WELL ABANDONMENT REPORT

API Number: 05-103-08982
Well Name: Taiga Mtn Well Number: 6-14-1-103
Location (QtrQtr, Sec, Twp, Rng, Meridian): NESW, 14-T1N-R103W 6th PM
County: Rio Blanco Federal, Indian or State Lease Number: C-17543
Field Name: Taiga Mountain Field Number: 80815
Complete the Attachment Checklist

From: Andrews, David
Sent: Wednesday, March 17, 2010 1:05 PM
To: 'Duran, Cody'
Cc: Ziegler, Joy; Nilson, Gary; 'Betty_Lau@blm.gov'; chadvannest@hotmail.com
Subject: RE: Taiga Mtn 6-14 followup

From: Andrews, David
Sent: Friday, March 05, 2010 8:45 AM
To: 'Ziegler, Joy'; Sencenbaugh, Bob
Subject: FW: Tiaga Mtn 6-14-1-103 P&A Procedures and As-Built Location Data
Attachments: Tiaga Mtn 6-14-1-103 WBD and Cmt Ticket.PDF; Tiaga Mtn 6-14-1-103 Form 6 SRA.PDF

WELL NAME: **Taiga Mountain 6-14-1N-103W**
 Footage: **1644 FSL, 1701 FWL,**
 LOCATION: **Sec 14 Twp 1N Rge 103W**
 FIELD: **Taiga Mountain**

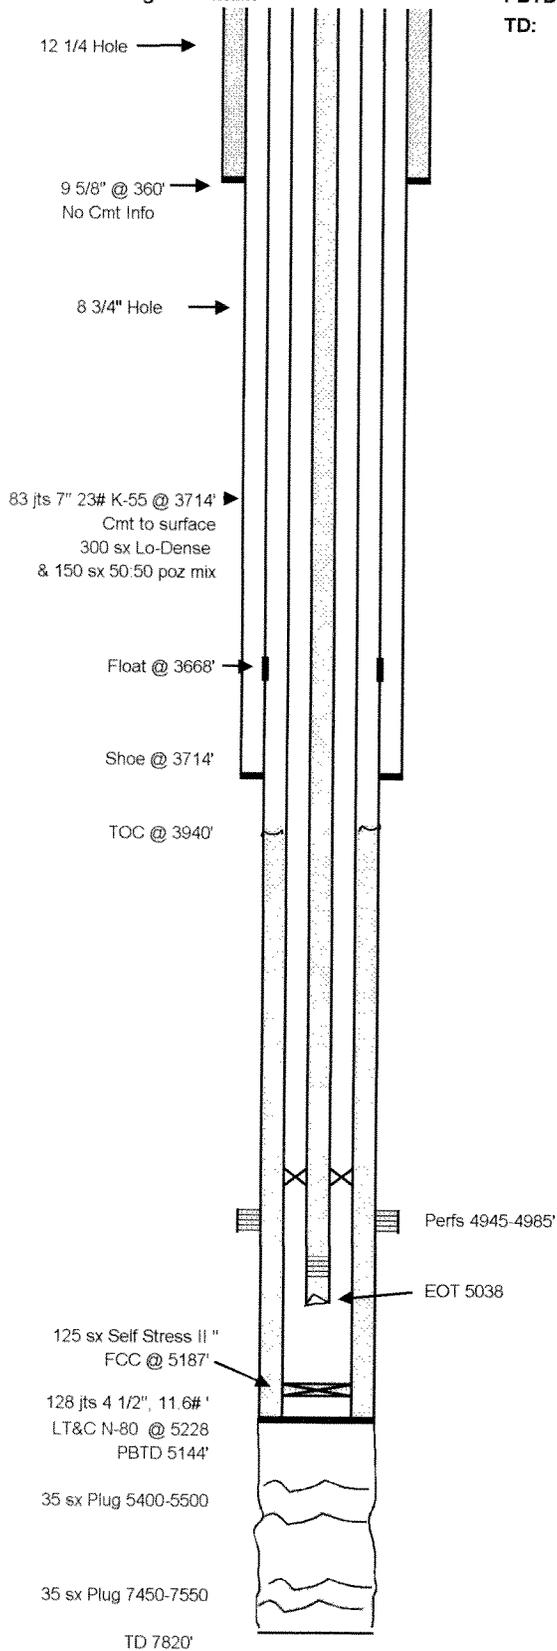
3. I have revised the form 6 to match the cement tickets and Joy has signed and attached. I have also attached a revision of your WBD to show my calculations and cement tops and bottoms.
